07/01540/OUT
WAN/19717/1-X

Rev	Description	Date	Checked
 Glanville Cornerstone House 62 Foxhall Road, Didcot Oxon, OX11 7AD Tel: 01235 815500 Fax: 01235 817700 info@glanville.gov.uk www.glanville.gov.uk			
Client:	Terry Ryland		
Project:	Priory Cottage Warrings		
Title:	Proposed Access Alterations		
Project Engineer:	J. Birch	Scale:	1:200 @ A3
Project Director:	P. Hodgson	Date:	July 2007
Status:	PRELIMINARY		
Drawing No.	TR270545/02		
Rev

County Engineer comments

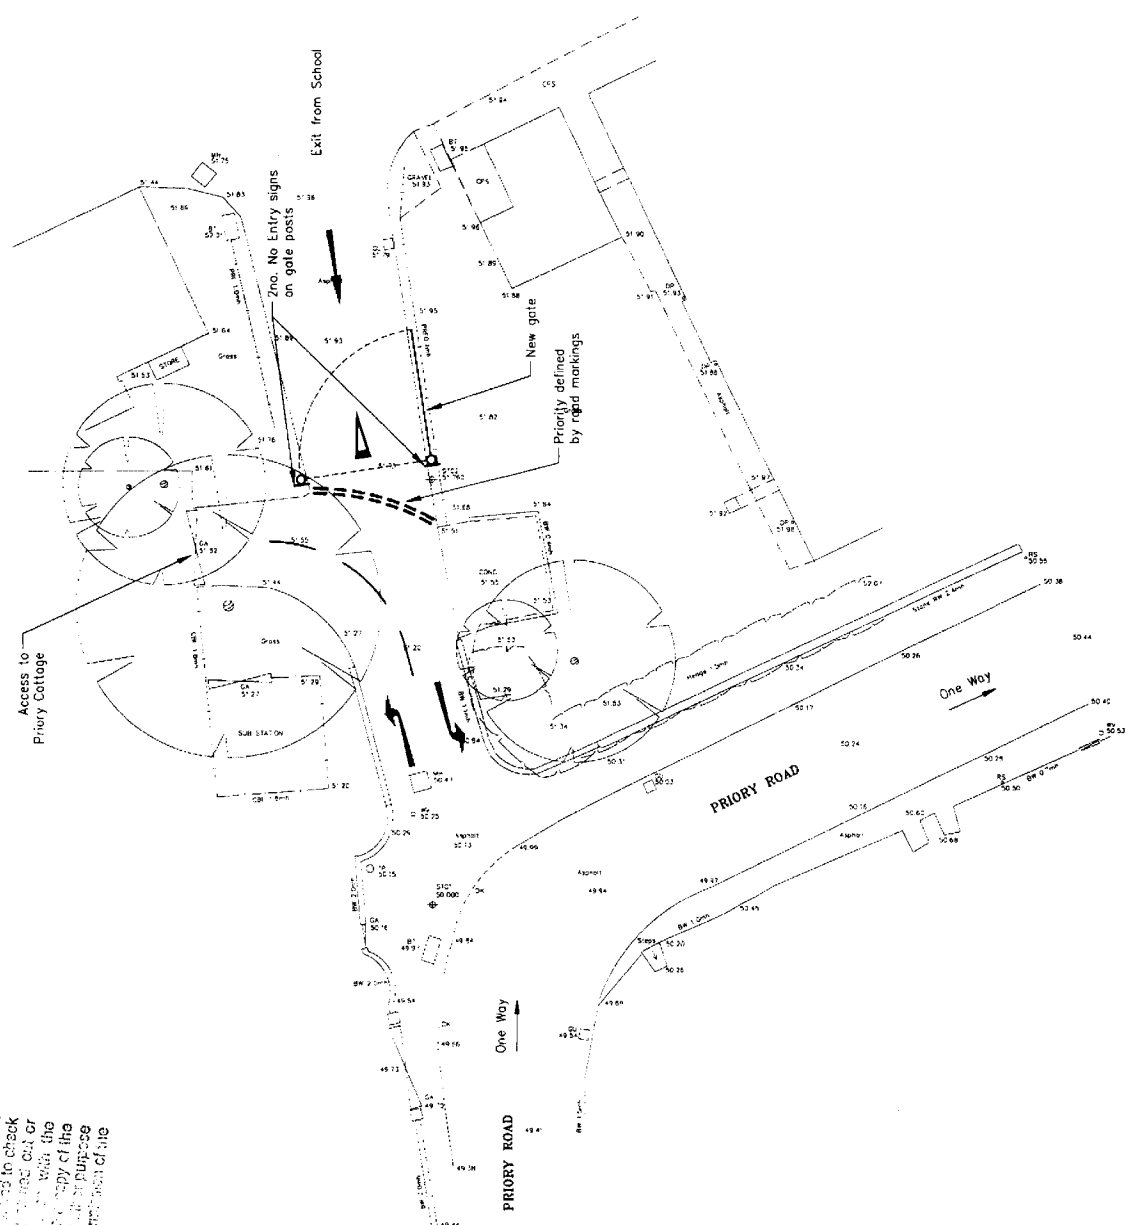
The proposed access/egress point for the proposal abuts the school egress, also used by pedestrians/cyclists into the school, onto Priory Road. Although the school operates an 'informal' one way system from Portway through the school this does not appear to be enforced – in any case the applicant appears to have a right of access against the informal one-way system.

The junction of the school egress onto Priory Road, a one-way road, has acceptable vision with vehicles only approaching from the right hand side. The geometry of the highway in the vicinity constrains speeds of vehicles approaching/passing the school egress.

The width of the school egress up to the highway boundary, a length of about 10 metres, is about 4 metres wide. Vehicles (cars) can pass each other in this width albeit slowly. Widening this width to ease passing of vehicles (say to 4.2 metres) may encourage speed where pedestrians/cyclists are to be expected.

- Ensuring priority for school traffic and the use of the rumble strip across the access proposed for the development,
- Similarly a rumble strip across the proposed school gate (and at the highway boundary) can only encourage low speed for vehicles egressing across the school. However, in this the accessibility to/from the school for users of wheelchairs, prams and cycles will need to be taken into account.

- Contributions to public transport infrastructure in the vicinity may be necessary by way of a Unilateral Undertaking – to be advised (informative)
- Given the length of the access to Priory Cottage and the proposed 2 dwelling units it would be appropriate to provide 2/no passing bays

- Any gates to the access should be set back 5.8 metres minimum and open inwards only to ensure no obstruction to the school egress
- Provision for the turning of servicing/emergency vehicles will need to be provided given the distance from the public highway. What is proposed for refuse collection given the vicinity?

- Pedestrian awareness vision splays would be improved by the removal of hedging on top of the retaining wall to the south and replacing with railings
- To ensure that deliveries/works necessary in implementing any permission that may be granted are submitted, in the form of a works/delivery management plan for consideration and approval.
